From: Howard Crabtree
Sent: Wednesday, August 24, 2016 6:37 PM
To: Brian Henry; DePaoli, Susan; Jeffery Crane
Cc: Andy Binford (Andy.Binford@tn.gov); Chris P. Thompson; Kristof Czartoryski; Randy Young
Subject: TDEC position on draft responses to D4/D2 EMDF RI/FS comments

CERCLA D4 RI/FS COMMENT AND (DRAFT) RESPONSE SUMMARY

Comments by: Tennessee Department of Environment and Conservation
 Comments Received: May 16, 2016
 Title of Document: Remedial Investigation/Feasibility Study for Comprehensive Environmental Response, Compensation, and Liability Act Oak Ridge Reservation Waste Disposal Oak Ridge, Tennessee
 Revision No.: D4
 Document No: DOE/OR/01-2535&D4
 Date: March 18, 2016

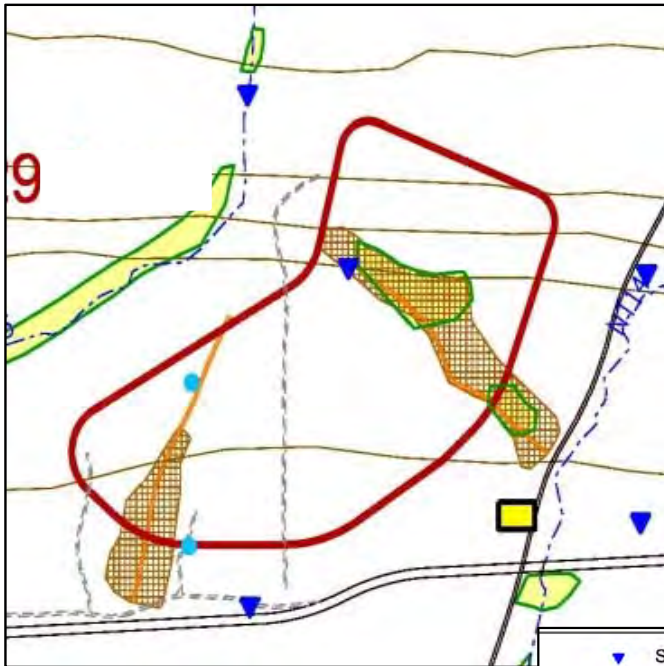
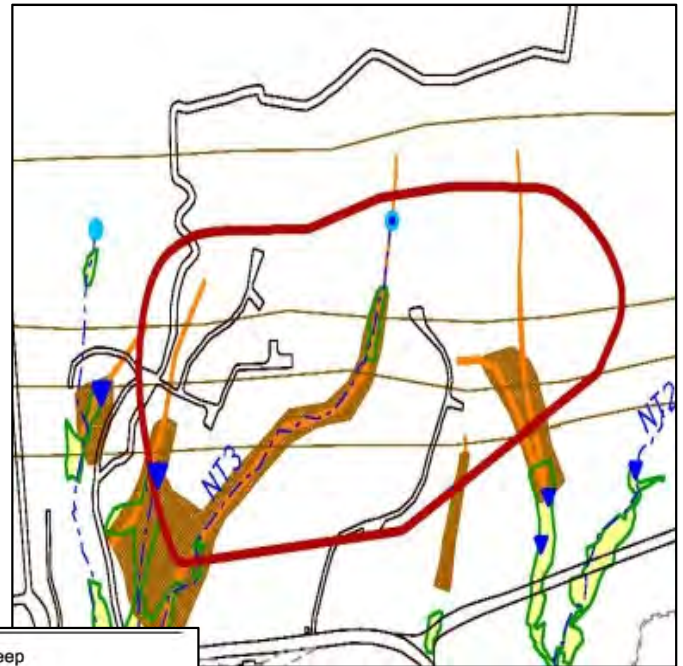
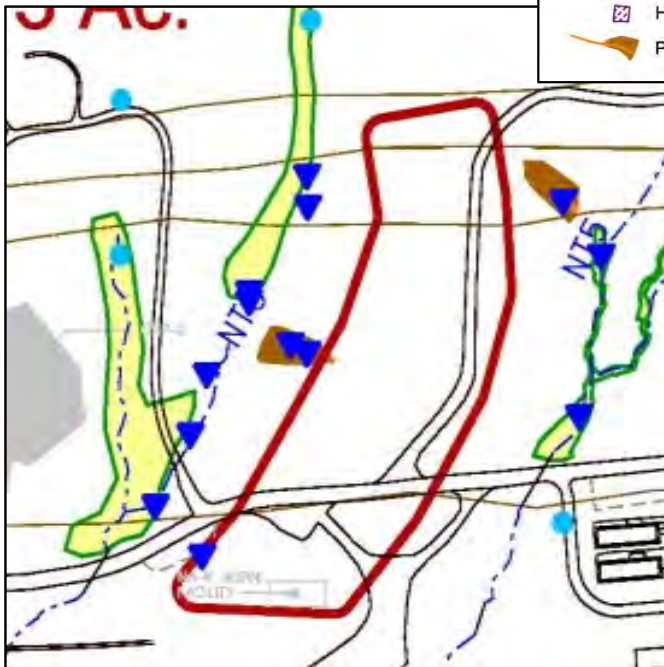
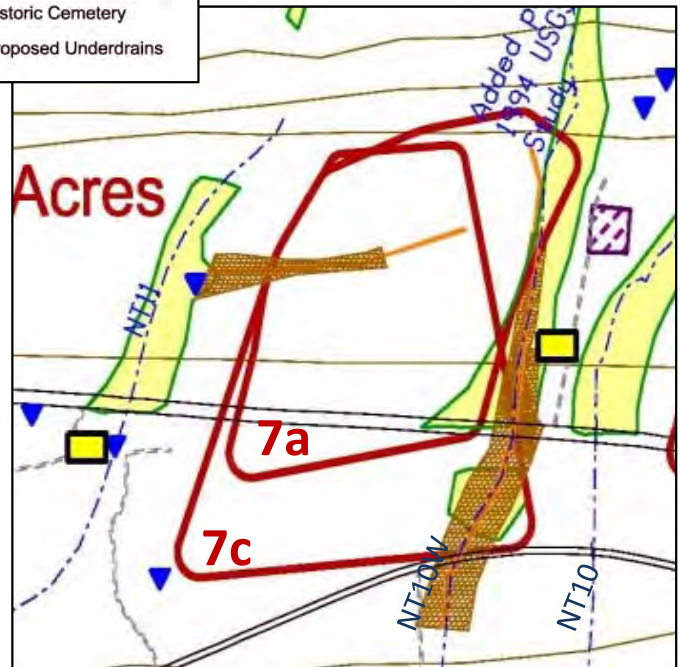
NRC guidance (NUREG 0902) states the rationale of this criterion: “*This requirement will result in a travel time for most dissolved radionuclides at least equal to the travel time of the groundwater from the disposal area to the site boundary. In addition, this requirement should provide sufficient space within the buffer zone to implement remedial measures, if needed, to control releases of radionuclides before discharge to the ground surface or migration from the disposal site.*”

All sites proposed for consideration will require grading to create a level base for construction. Site grading will raise the base of the landfills above the pre-construction high water table, by significant amounts in some areas. A geologic buffer of either in place soil, fill from cut areas, or purchased fill (all of which must meet specific low permeability requirements) is placed to ensure a minimum unsaturated material thickness of 10 feet above the seasonal high water table of the uppermost unconfined aquifer or the top of the formation of a confined aquifer [TDEC 0400-11-01-.04(4)(a)(2)]. Above this geologic buffer, the liner system is installed. The liner system includes three feet of compacted clay, geosynthetic layers, a one foot leachate collection drainage layer, and a final one foot protective material layer (five feet total), above which the waste is placed (consistent with RCRA requirements). The geosynthetic layers are water impermeable materials that have been simulated in multiple independent tests to function for many centuries. These features will isolate the short-lived radionuclides so that decay occurs in place; therefore, they will not present a risk to human health or the environment (see discussion in main document Section 6.2.2.4.8). The geosynthetic materials ensure that leachate does not contaminate the underlying groundwater during the service life of the synthetic liner components. These three features (geologic buffer, liner, and geosynthetics within the liner) along with the material specifications they must meet (e.g., per RCRA) exceed design requirements specified in the TDEC NRC-based *Licensing Requirements for Land Disposal of Radioactive Waste* (TDEC 0400-20-11), which does not require any

material, liner, or other engineered feature between the waste and the hydrogeologic unit used for disposal.

As explained, the conceptual design for the EMDF at all BCV candidate sites incorporates a minimum 15 ft vadose (unsaturated) zone, comprised of the liner and geobuffer between the waste and high water table. Conceptual designs of all sites proposed for consideration include engineered underdrain systems installed beneath the geobuffer to capture and divert groundwater discharge and maintain the minimum thickness of the vadose interval. In addition, in-situ and structural fill materials incorporated to level the footprint provide additional vadose zone thickness beneath a significant portion of the waste for all sites, increasing average depths to groundwater to approximately 25-30 ft. Minimally, vadose zone depths are thus 15 ft, with maximum depths in isolated areas at some sites reaching 90 ft. In the event that contaminants are released from the waste, the underlying vadose zone depth provides an extended travel time that would greatly exceed the travel time of the groundwater from the disposal area to the site boundary as targeted by the siting criterion.

After closure of the landfill facility, the 11 foot final cover system, which also includes geosynthetic layers, ensures that recharge to the footprint is severely limited for hundreds and up to thousands of years, minimizing release of contaminants and further ensuring that groundwater tables remain lowered. During the post-closure period of DOE institutional control of the facility, maintenance and monitoring of the leachate collection and leak detection systems along with required groundwater monitoring (e.g., RCRA Subpart F) will provide indications of potential releases of radionuclides to groundwater and permit the implementation of remedial measures prior to discharge to the ground surface or migration from the disposal site.

Per CERCLA, a waiver for this requirement may be requested on the basis of "equivalent protectiveness", under 40 CFR 300.430 (f)(1)(ii)(C)(4) *The alternative will attain a standard of performance that is equivalent to that required under the otherwise applicable standard, requirement, or limitation through use of another method or approach.* As discussed above, the additional engineered features (geologic buffer, liner, and geosynthetics within the liner and cover systems) are over and above design requirements noted in TDEC 0400-20-11, and along with additional vadose zone thickness provided through site grading provide an equivalent protectiveness to that intended by the siting criterion.
